Key Concerns

Fix #1 - Improve Unit Mix

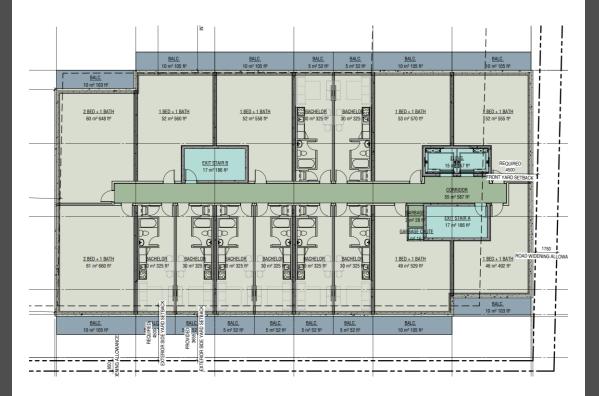
- Unit mix
 - Significant overabundance of bachelor units
 - Performing poorly in several markets
 - Subpar long-term livability for owners/ tenants
 - Lose-lose-lose for City, developer, & residents
- Tower massing changes
 - Unnecessary
 - Looks top-heavy
 - Added construction complexity
 - Need some vertical breaks in the balconies

- Apply the upper tower floor plate throughout
 - Create 4 new 1B+D units/ floor.
 - Remove all bachelor units.
 - Overall unit count becomes 272 (from 328).
 - Parking ratio up to 0.55 (from 0.46).
 - Simplifies construction by losing 22nd floor rotation.

Fix #2 Tower Façade Continuity

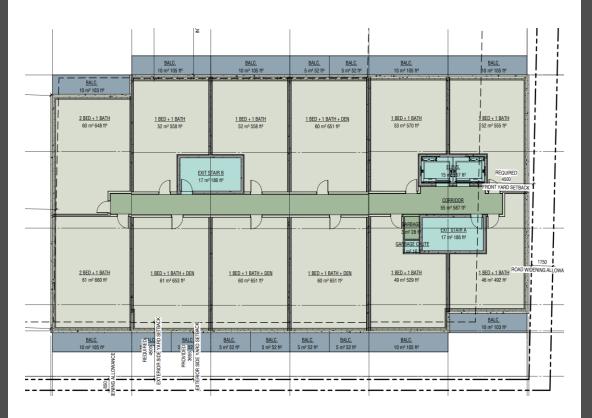
- Apply the lower tower balcony layout throughout
 - Creates good-sized balconies for all units.
 - Again, reduces construction complexity.
 - Can also make the tower appear shorter.
- Vertical balcony separation
 - Breaks up the massing/imposing scale of the longer tower wall.
 - Creates a more visually interesting building near the riverside.
 - Improves resident experience feeling of hanging off building eliminated.
 - Increased privacy for residents. Views remain intact.
 - Gaslight District tower sections do this reasonably well.

Conceptual
Vertical
Delineation
Positioning

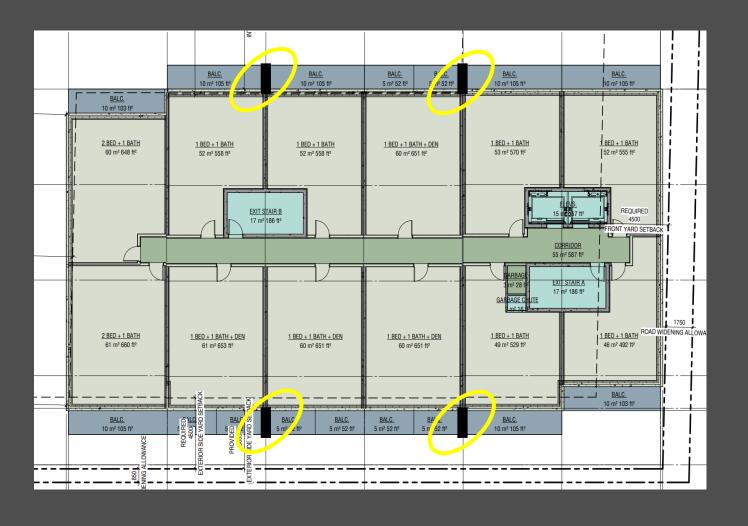
- Definitive vertical separation of balconies every 2 units across longer façade.
 - Less visible partitions between paired balconies.
 - Breaks up horizontal mass of the structure.
- Horizontal emphasis every 2 floors up the tower.
 - Creates the illusion of fewer floors/ a shorter building without height reduction.
 - Vegas utilizes this tactic constantly (Bellagio likely best example).
- Brick detailing on the NE edge LOVE IT!
 - Consider replicating this look on

MORE BRICK

VERTICAL SEPARATION
